| Product hierarchy no. * |     |     |            | Part no.       | SBU                            | Type / Description | Customer part no. |
|-------------------------|-----|-----|------------|----------------|--------------------------------|--------------------|-------------------|
| 02                      | 006 | 019 | 0000001800 | See list below | Power Entry Module with Filter | 5003               |                   |

**2 Type of change**

Filter cases for front and rear mounting have a new surface treatment process.

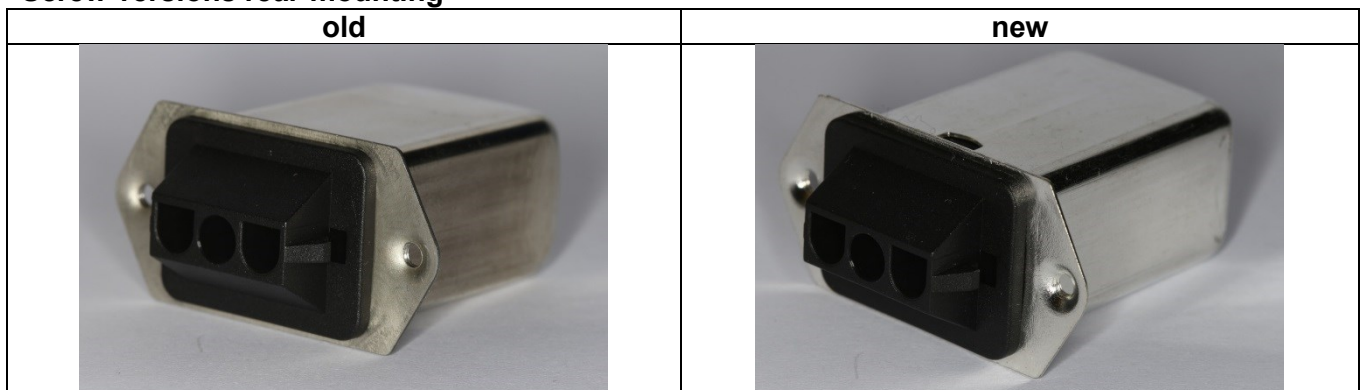
Surface treatment process of filter case has changed with no change of surface material.

**Screw versions front-side**

**Screw versions rear-mounting**
